**SUBJECT: ON Semiconductor Product Bulletin #15001**

**TITLE: Standoff Height Dimension Change for the 16 Lead SOICW EPAD Package**

**SOIC 16 LEAD WIDE BODY, EXPOSED PAD**  
CASE 751R-02  
ISSUE B

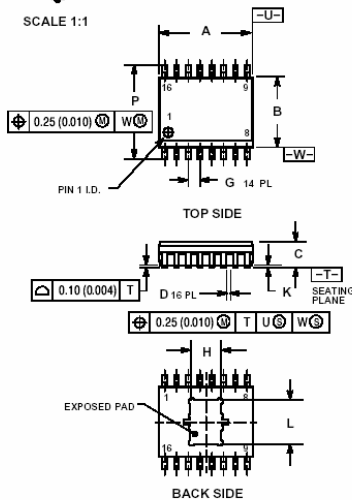
ON Semiconductor will be reducing the standoff height dimension to 0.00 - 0.10 mm, of the 16 lead SOICW EPAD package to improve solderability. This is in accordance with industry practices. Device reliability and performance will not change.
